Whidbey Noise Analysis Technical Review & Resolution

9 June 2017

Figure 1. Updated Departure Profile for EA-18G

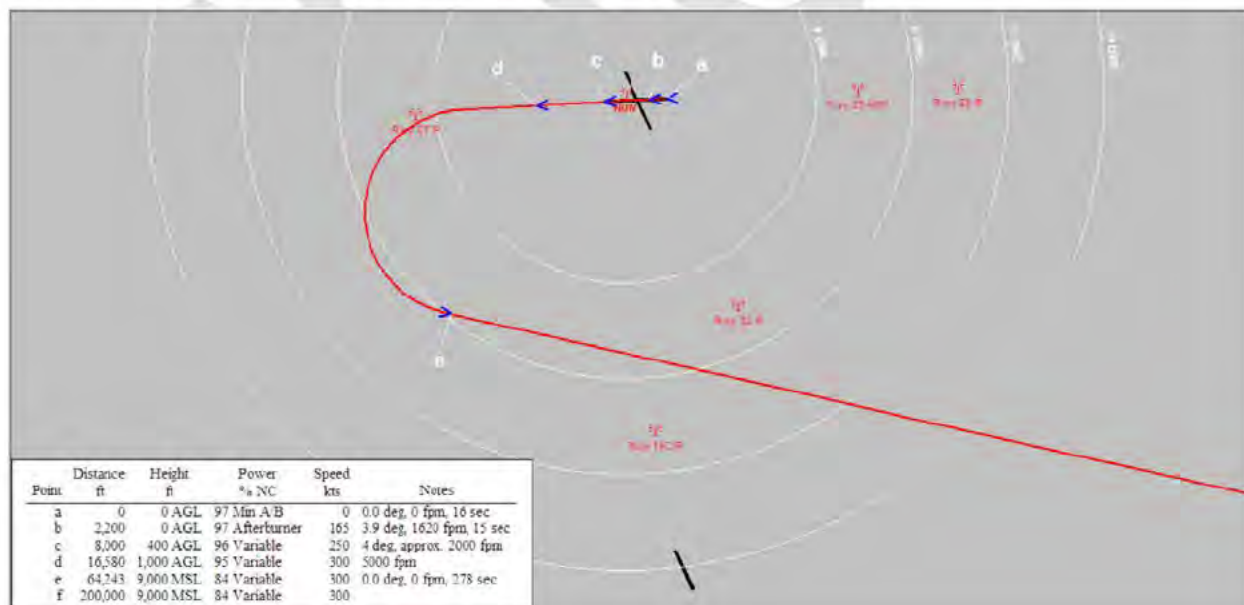
2. Steep Departure Flight Profile from Ault Field

Clarify modelled AB departure profile for the EA-18G. The modelled profile has a steep climb at the end of the runway going from 400 ft AGL to 1,500 ft AGL in 1,250 ft of track distances. This results in an effective climb rate of approximately 20,000 ft/min. Additionally, after this steep climb, the climb out rate confirmed through pilot mark-ups is less than the modelled profile.

RESOLUTION: The departure profile was updated with a slower climb out rate until cruise altitude is reached. The update is based on inputs received on 22 May 2017 from the Navy. The initial climb out is modeled at 2,000 ft/min and then increases to 5,000 ft/min approximately 1.3 nm after the end of the runway. The updated profile is provided in Figure 1. The combination of 100% AB departure and the slower climb out rate results in increases in the DNL levels.

Figure 2. Updated Overhead Break Arrival Profile for EA-18G

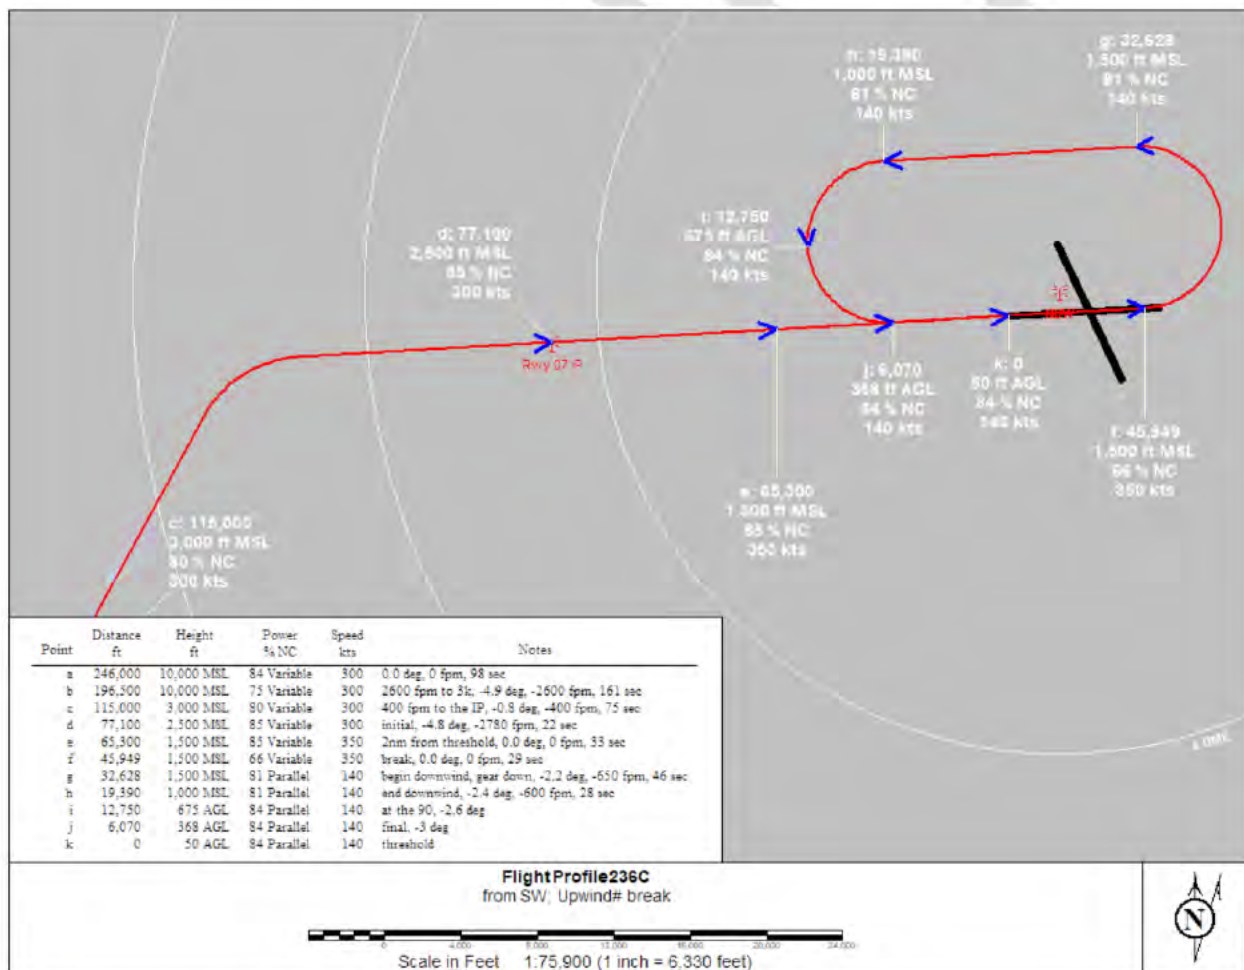
3. Flight Profile/Power Settings for Overhead Break Arrival

The modelled overhead break arrival profiles for the EA-18G have differences relative to overhead break arrival profiles used at other airfields. The main differences are maintaining engine power at 85% NC through the breaking turn to downwind and reducing engine power to flight idle for the downwind leg. At other airfields, engine power is cut to flight idle at the break and then increased to 85% NC on downwind leg as the aircraft configures. Other differences are the EA-18G descending and decelerating on the downwind leg rather than maintain level flight and constant airspeed. The descent and decelerations does not seem large enough to account for aircraft maintaining a flight idle engine power setting while also configuring the aircraft.

RESOLUTION: The overhead break arrival profile was updated to have flight idle engine power at the break point and establish 81% NC engine power at the start of the downwind leg. The updated overhead break profile is provided in Figure 2. The overhead break arrival portion of the interfacility profiles between Ault Field and OLF Coupeville were also updated with the same parameters.

Figure 3. Departure portion of the Interfacility Profile from OLF Coupeville to Ault Field

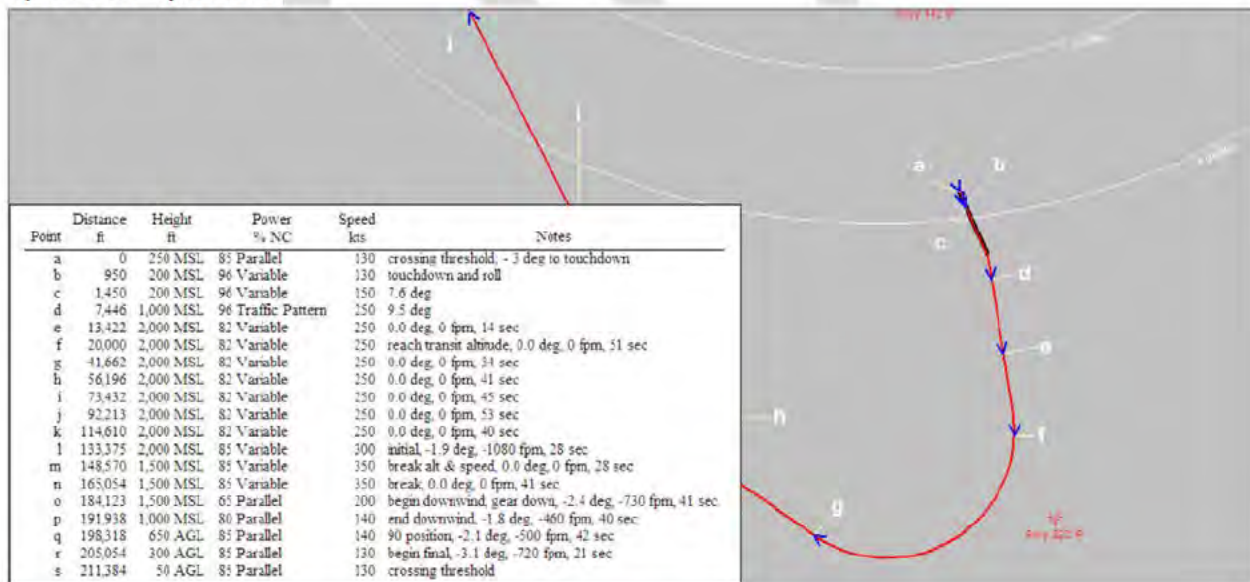
6. Full Stop Departures at OLF Coupeville

The modelled departures from OLF Coupeville are full-stop departures.

RESOLUTION: The interfacility departures from OLF Coupeville were updated to be a rolling departure as shown in Figure 3. This update has negligible impact on the overall DNL values since this area is controlled by the FCLP operations.
